**DOCUMENT 00 90 00  
ADDENDUM**

**ADDENDUM NO. [4]                      Date: November 21, 2018**

**RE:                      GLENWOOD COMMUNITY SCHOOL DISTRICT  
ATHLETIC COMPLEX IMPROVEMENTS BID PACKAGE 2 REBID  
400 SIVERS ROAD  
GLENWOOD, IOWA 51534  
HSR PROJECT NO. 18005**

**FROM:                  HSR Associates, Inc  
100 Milwaukee Street  
La Crosse, WI 54603  
(608) 784-1830**

**E201R**

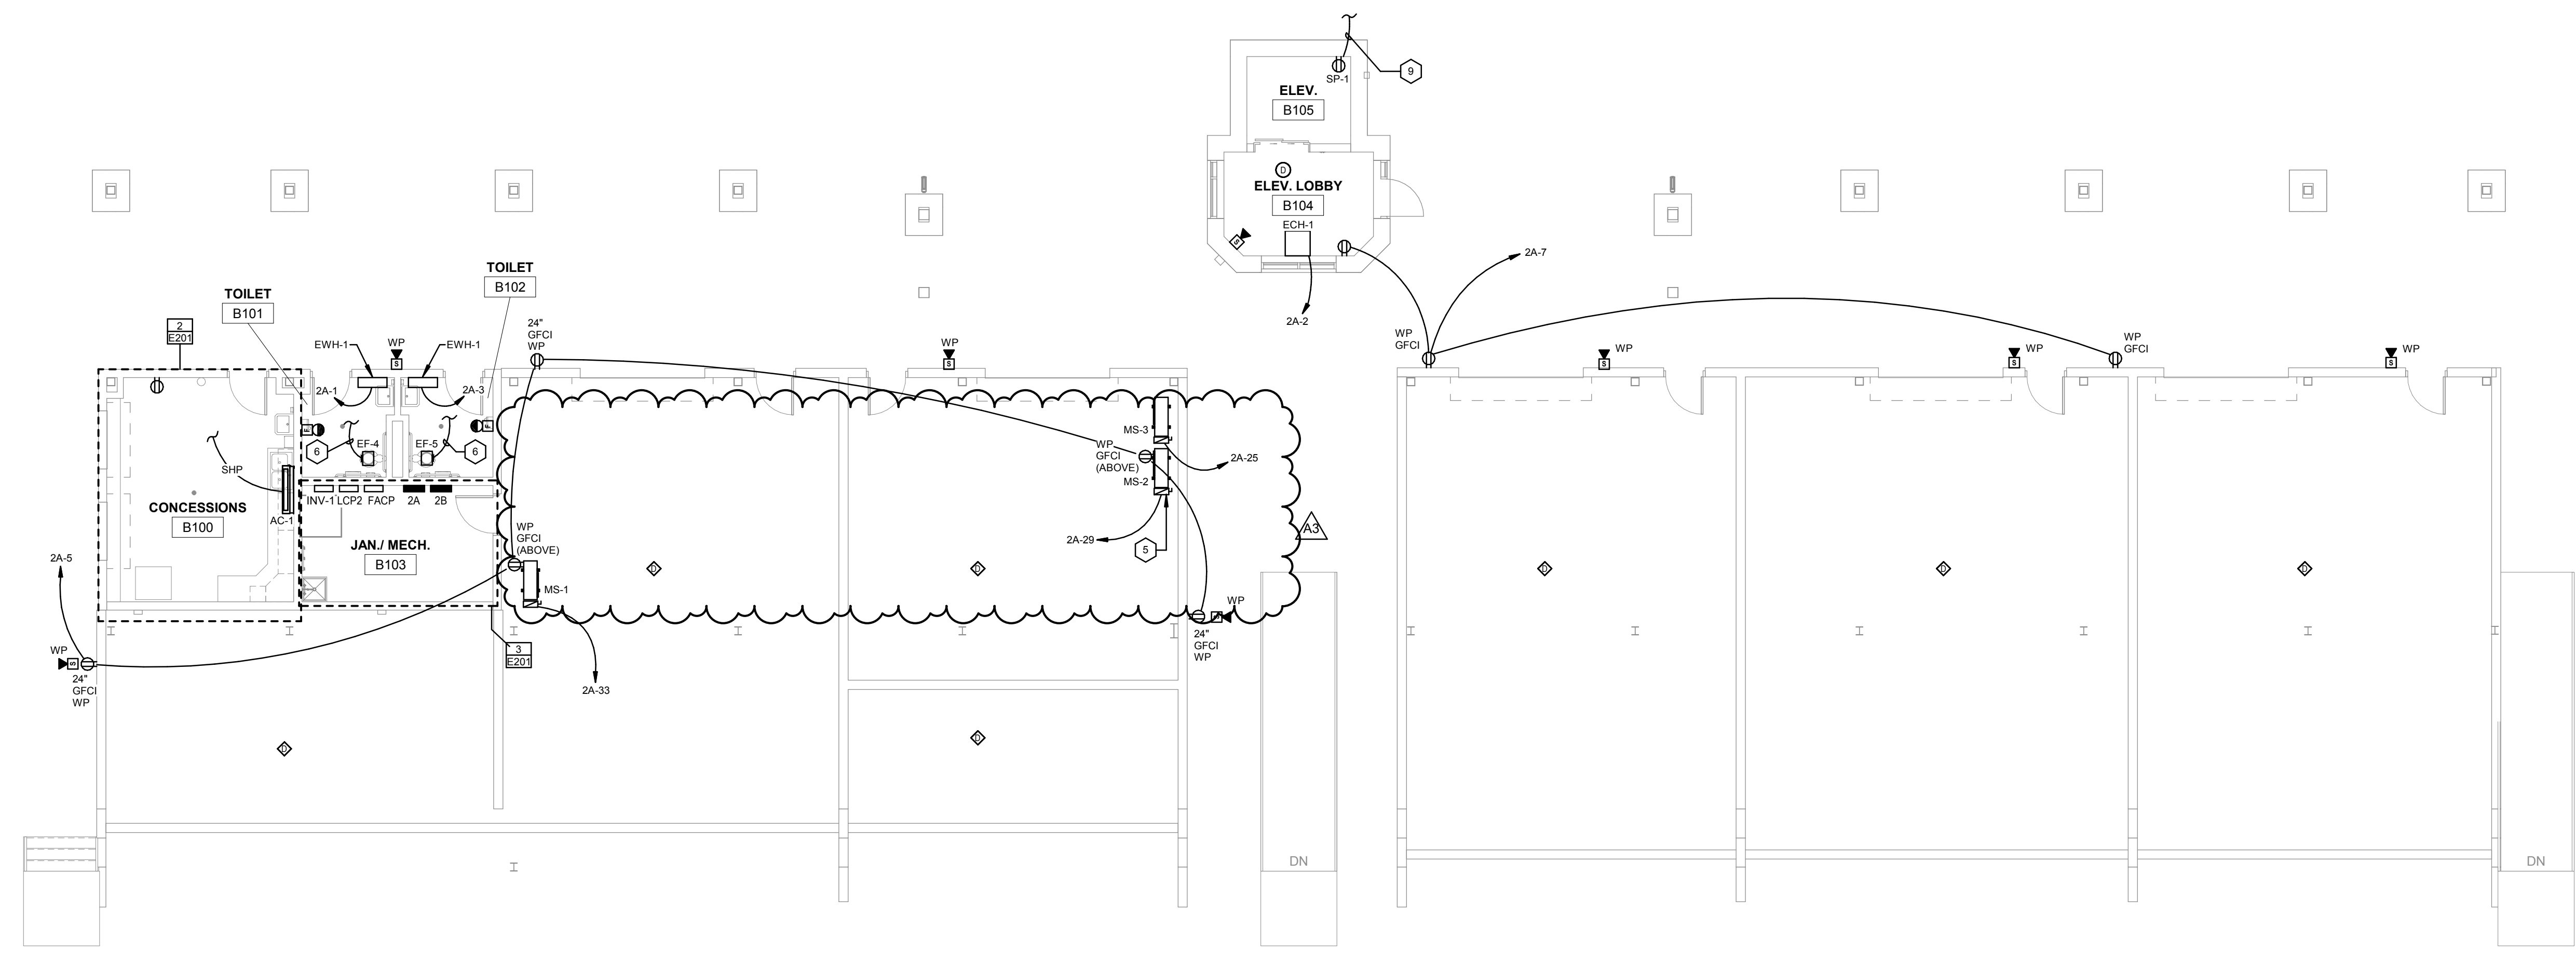
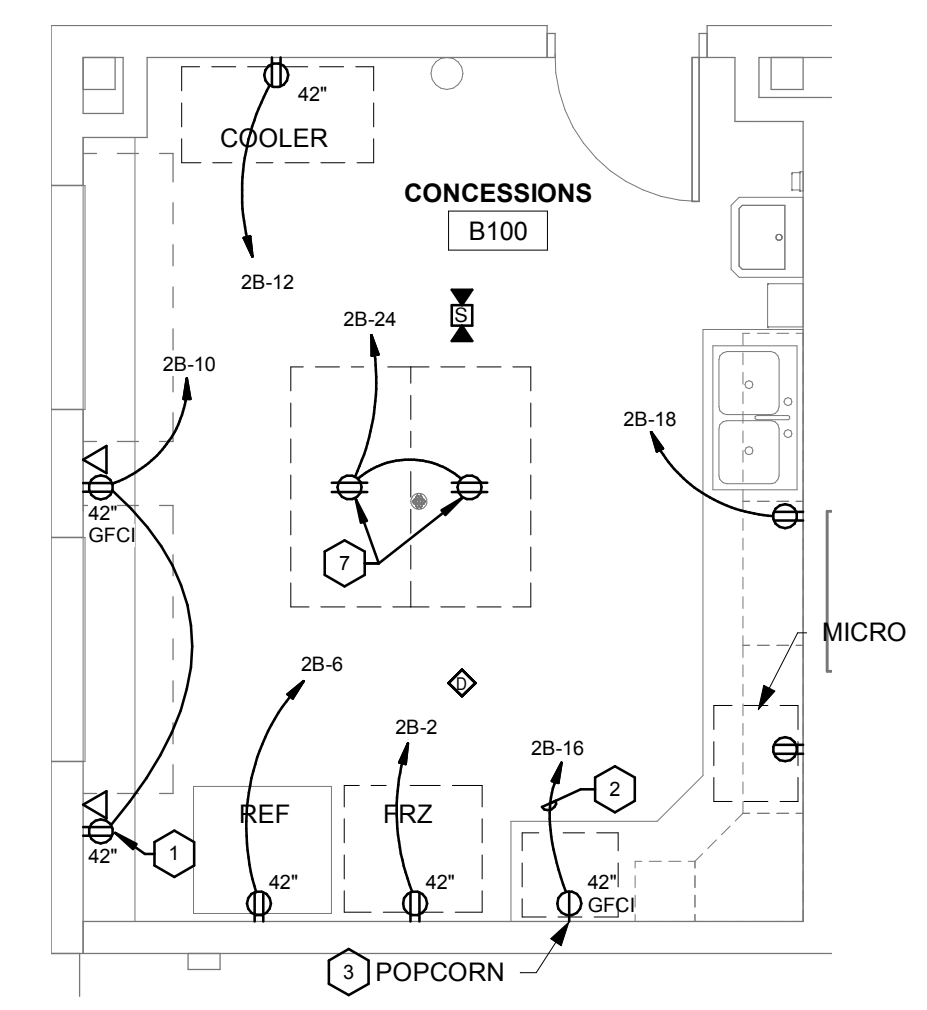
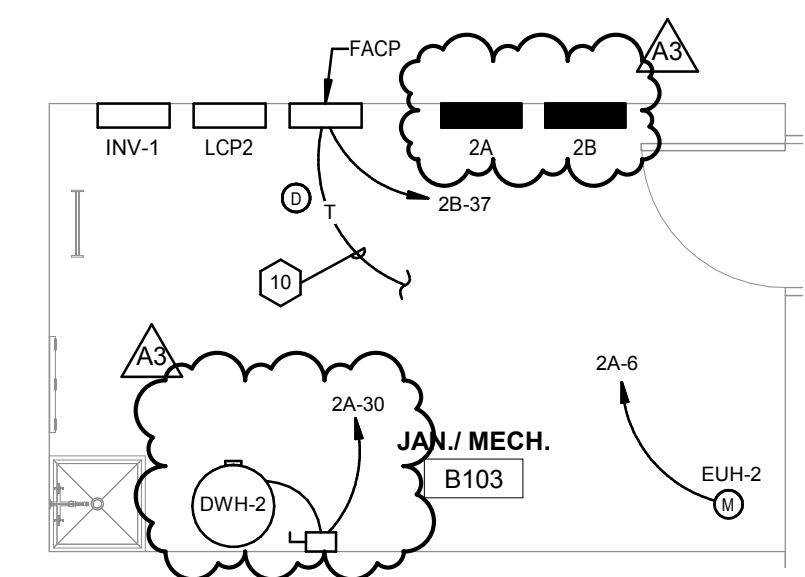
11. Sheet E201R FIRST FLOOR STADIUM POWER PLAN 30 x 42 attached hereto.
- a. Revisions clouded on Drawing
  - b. MS-1, 2, 3 location moved – Circuits to each unit relocated.

- c. DWH-2 location moved in JAN./MECH B103 – Circuit relocated.
  - d. Panels 2A/2B in JAN./MECH B103 relocated from behind door.
12. Sheet E300R ELECTRICAL SCHEDULES 30 x 42 attached hereto.

**E400R**

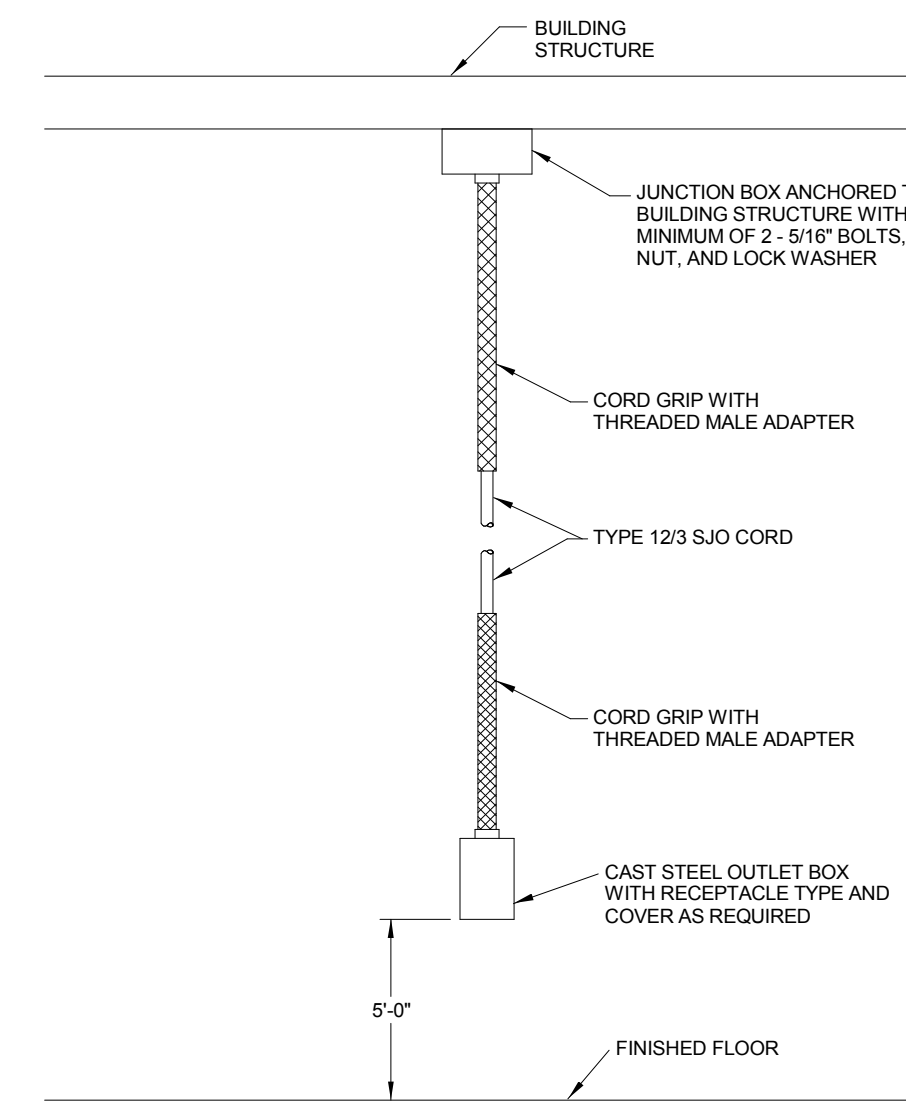
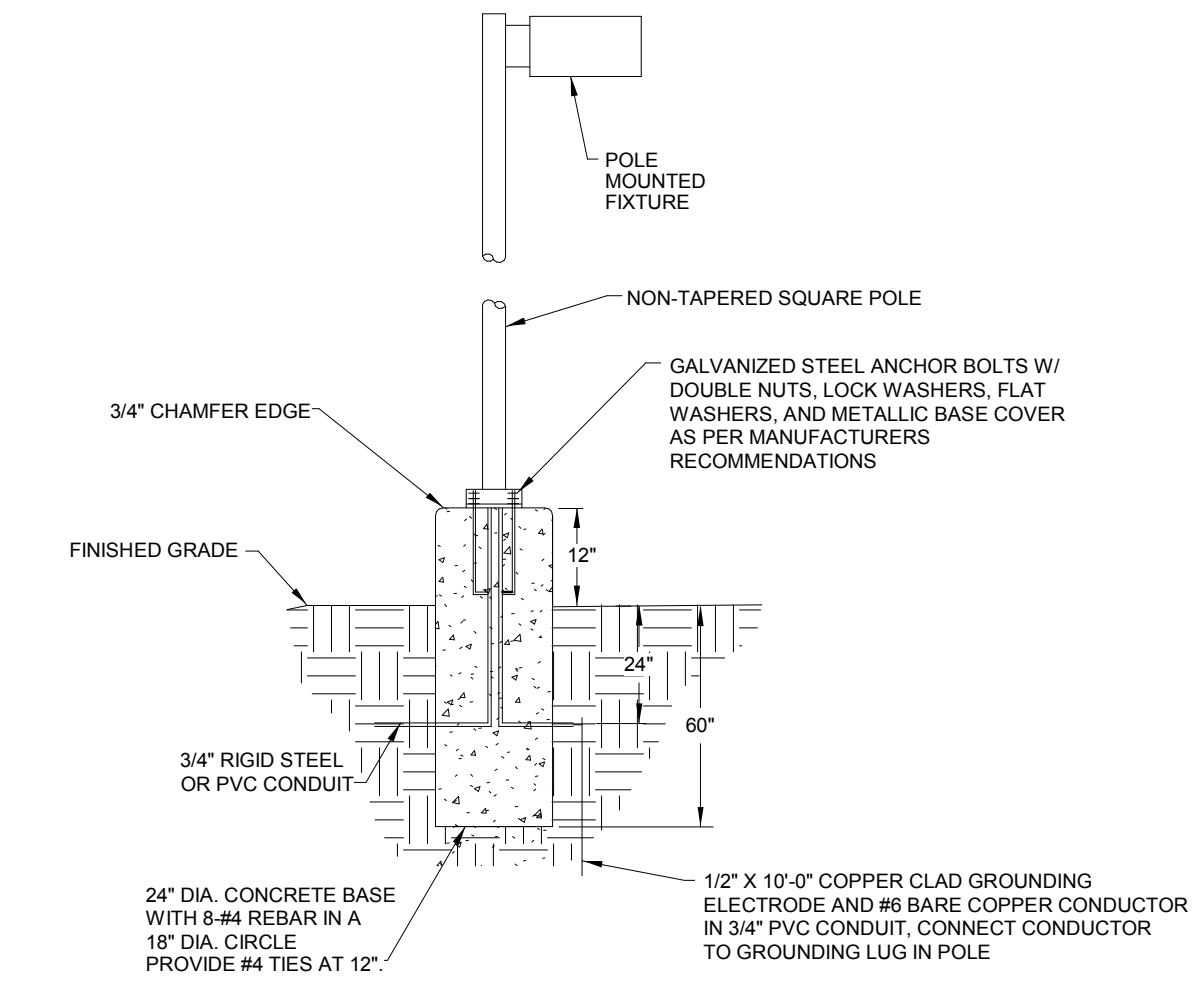
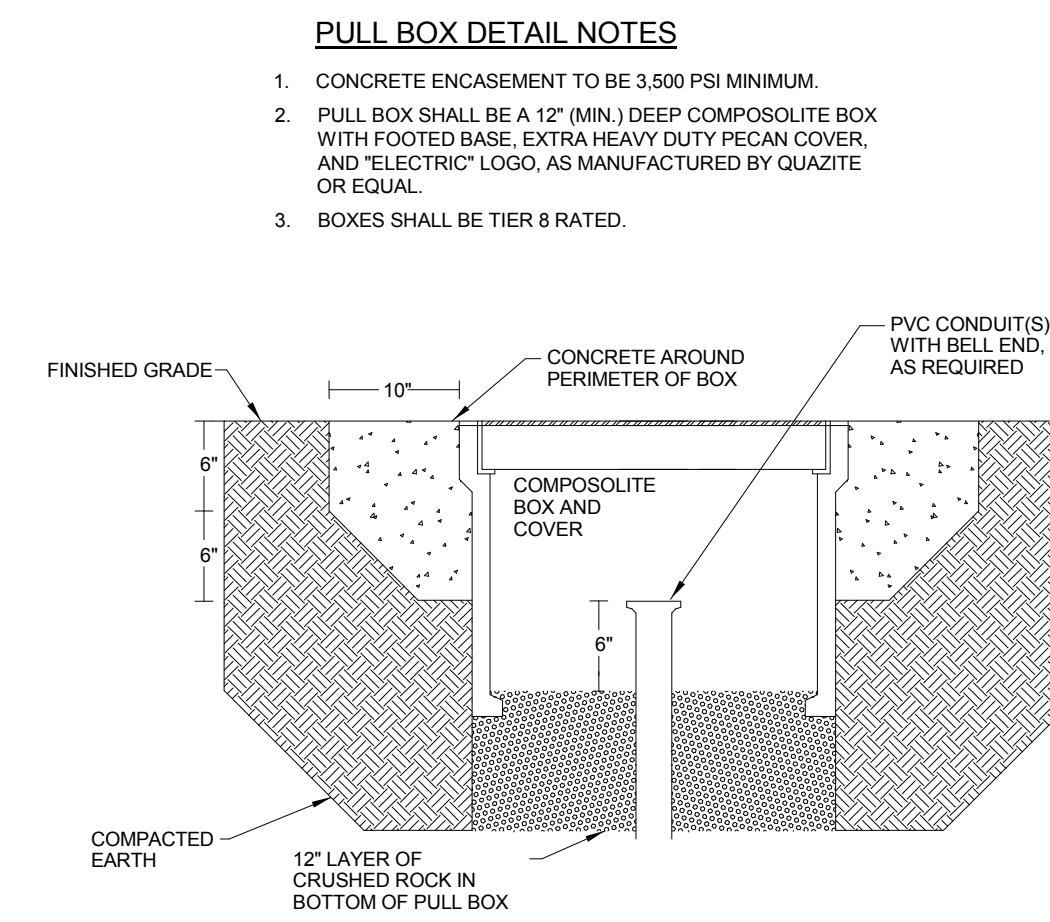
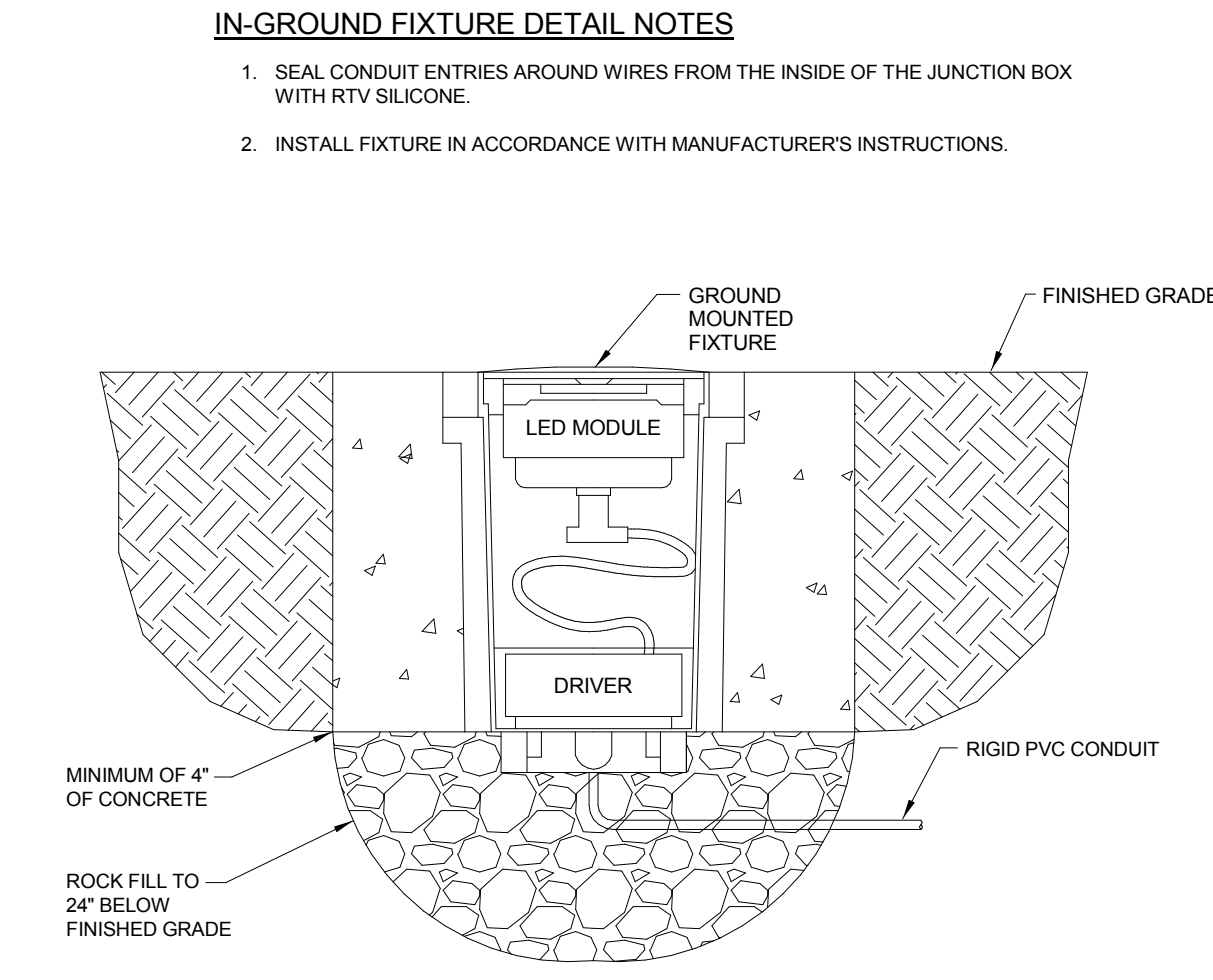
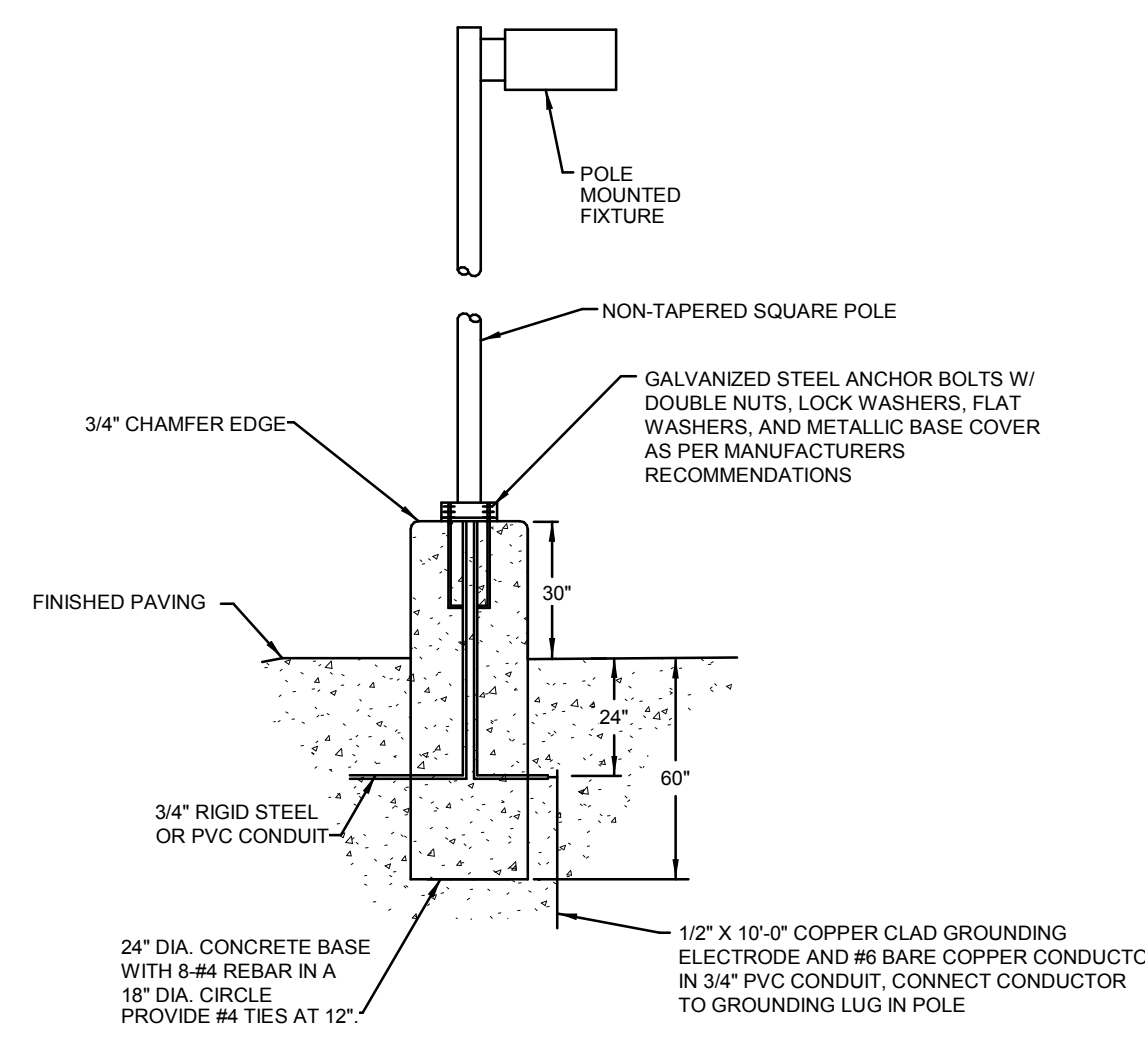
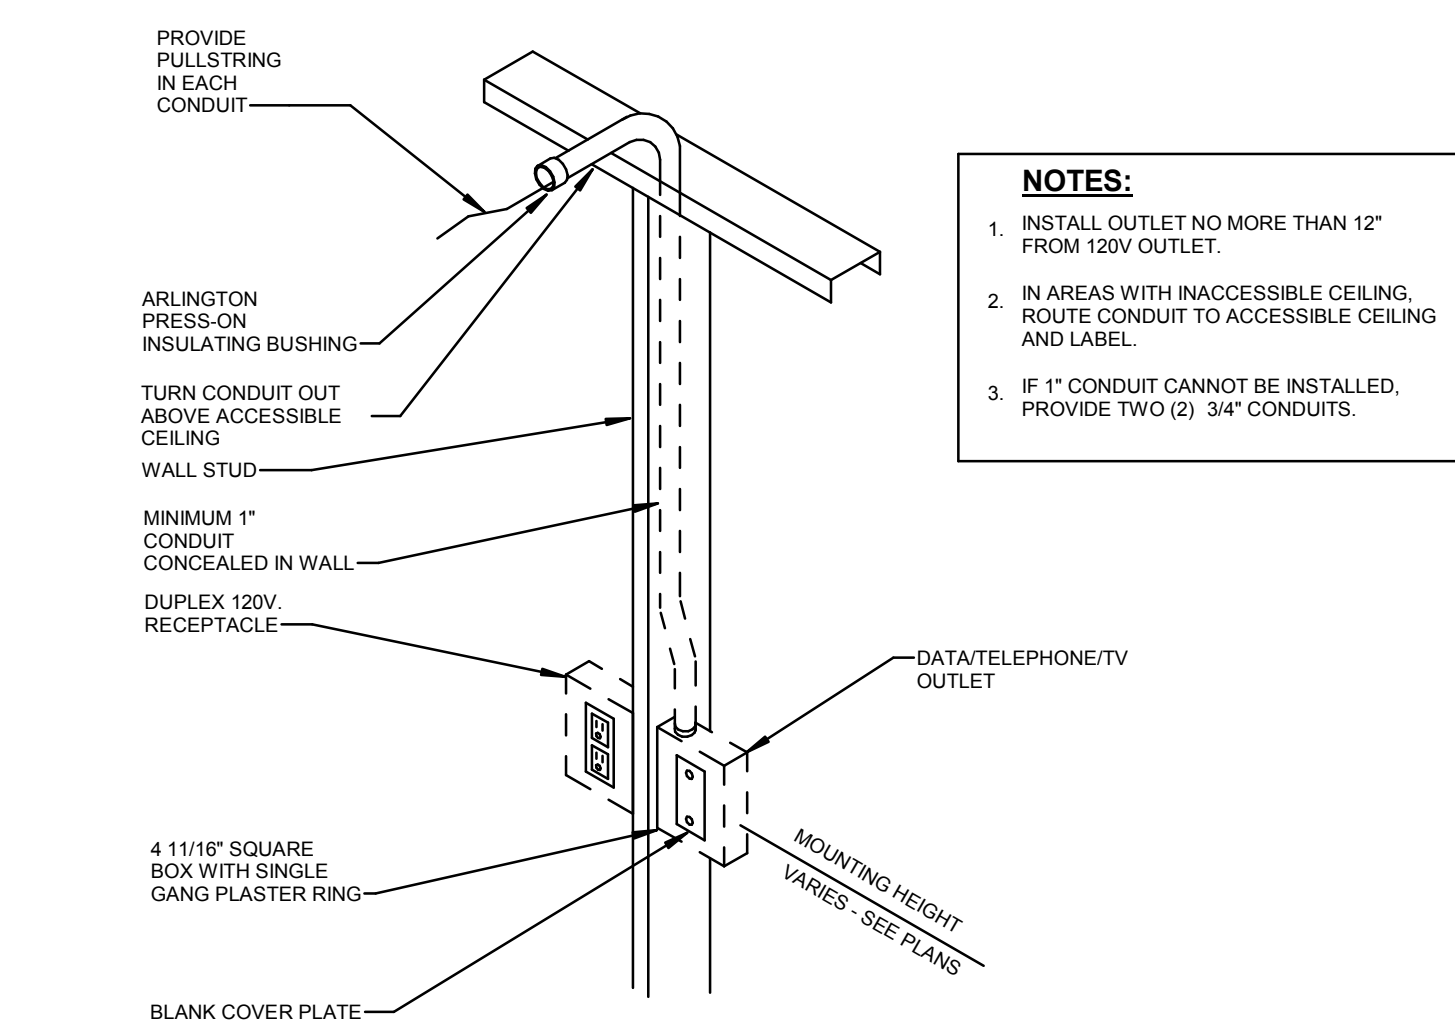
13. Sheet E400R ELECTRICAL DETAILS 30 x 42 attached hereto.
- a. Revisions clouded on Drawing
  - b. Two Electrical Details were removed from this page
